**BALDWIN COUNTY BOARD OF ADJUSTMENT #1**

# ZVA25-59 KANHA DEVELOPERS PROPERTY

## VARIANCE REQUEST

## VARIANCE REQUEST SUMMARY AND RECOMMENDATION

# Site Plan

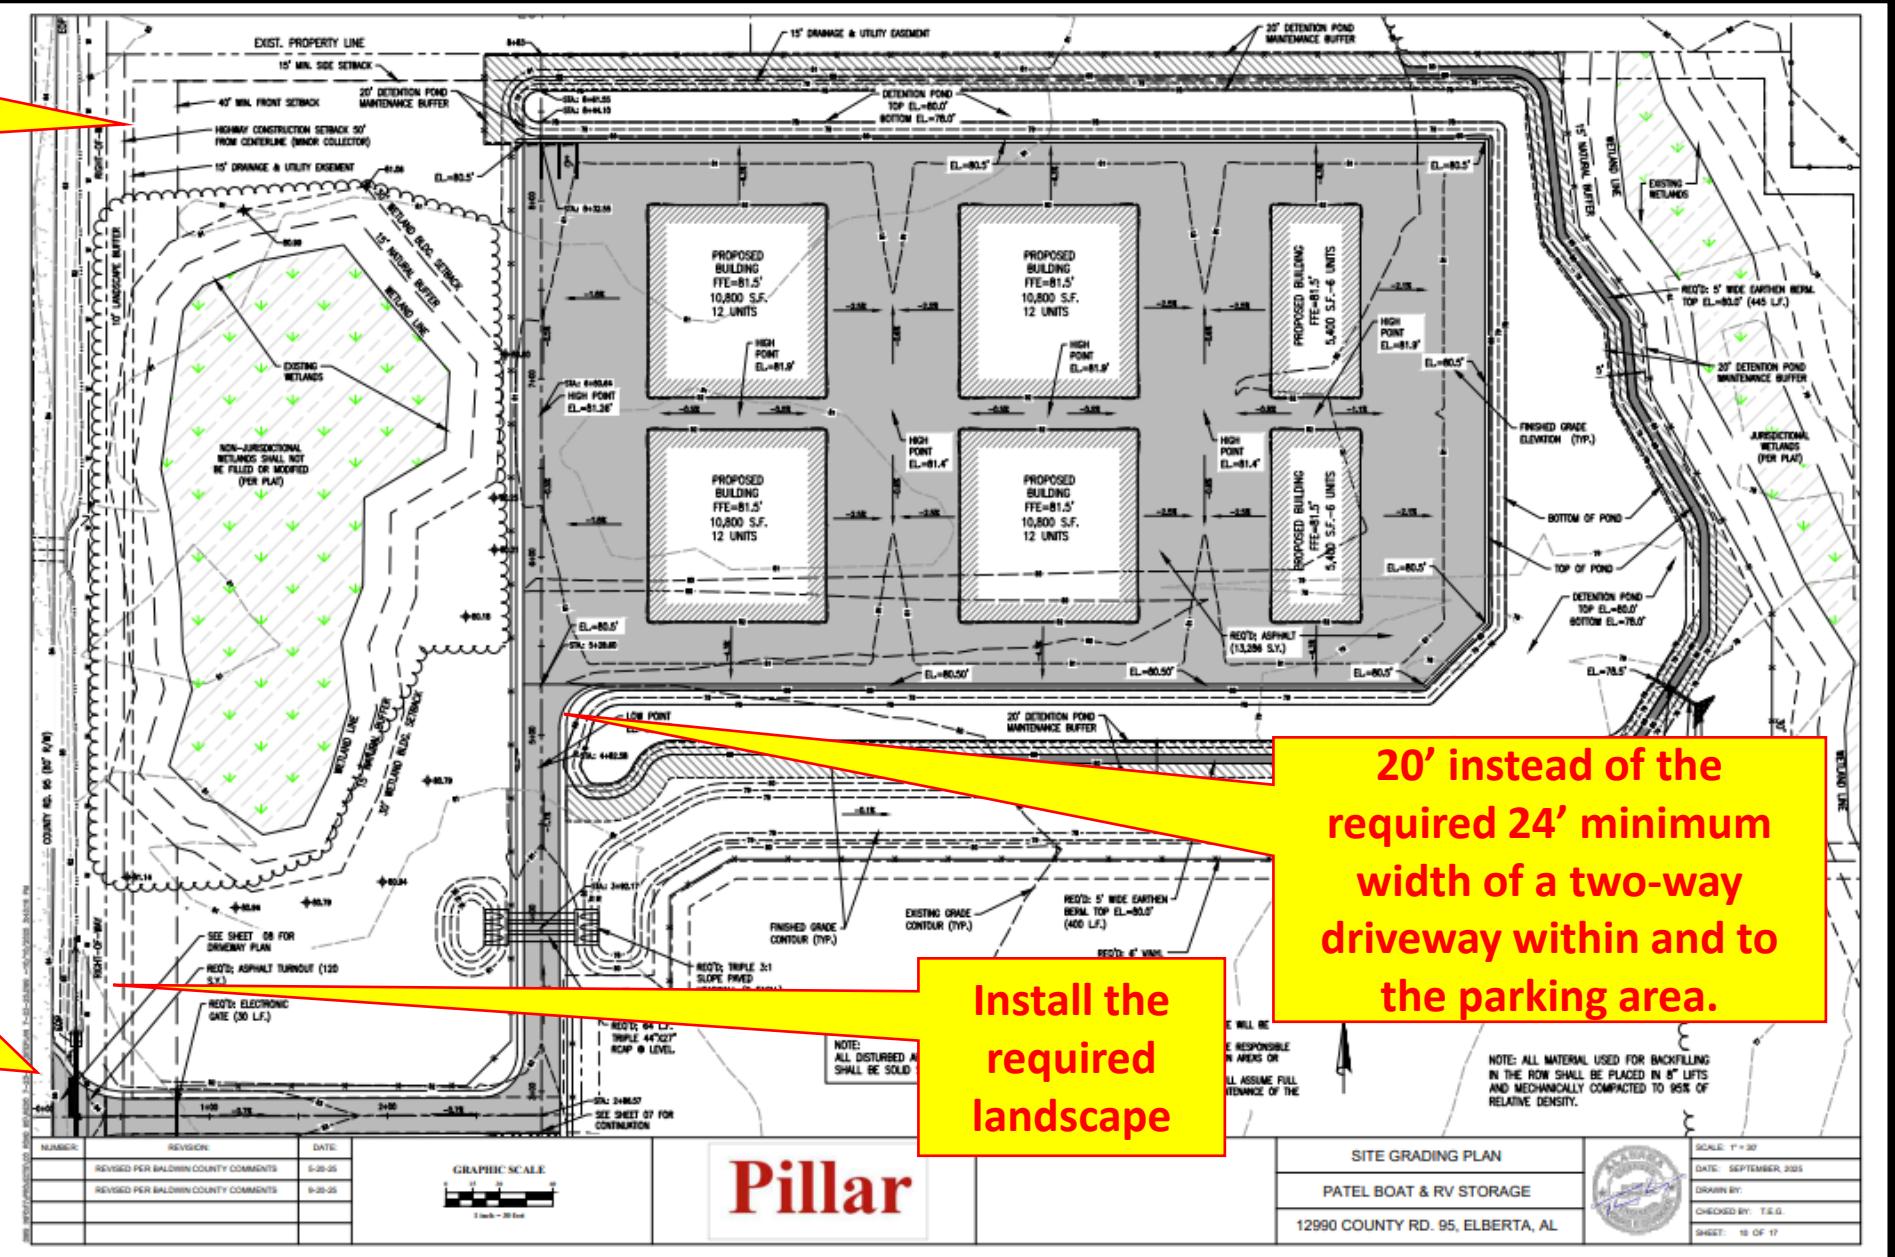
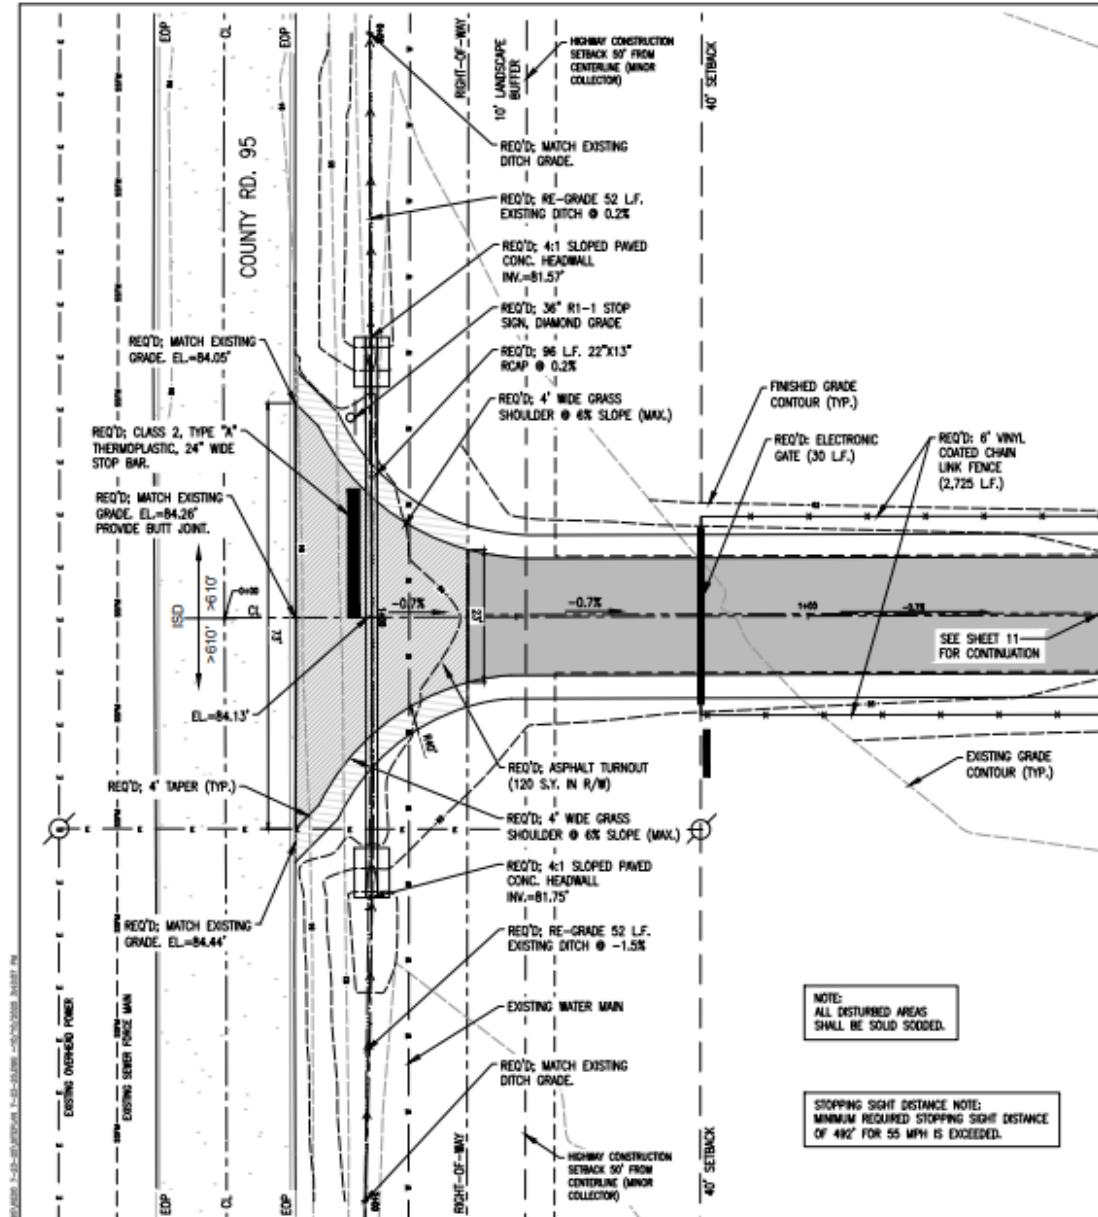
The applicant is requesting a variance from Section 17.2(a) regarding the 10-foot landscape buffer along a collector road, as well as from Section 15.3.3, which specifies that two-way access driveways adjacent to parking areas along County Road 95 must have a minimum width of 24 feet, in order to allow for RV/Boat storage.

The applicant requests that landscaping not be installed along the front adjacent to County Road 95 and also requests that the minimum width of the two-way access driveways within and leading to the parking areas be less than 24 feet.

Install the required landscape

20' instead of the required 24' minimum width of a two-way driveway within and to the parking area.

The staff acknowledges a hardship on the subject property regarding Section 17.2(a) and recommends that **approval be granted solely for the portions of the wetlands delineated on the site plan, while maintaining the required buffers on the north and south sides of these delineated wetlands on the site plan.**

Regarding Section 15.3.3, **staff does not perceive a hardship** related to the minimum width of the two-way access driveways within and leading to the parking areas for case number **ZVA25-59 and recommends this portion of the case be denied.**
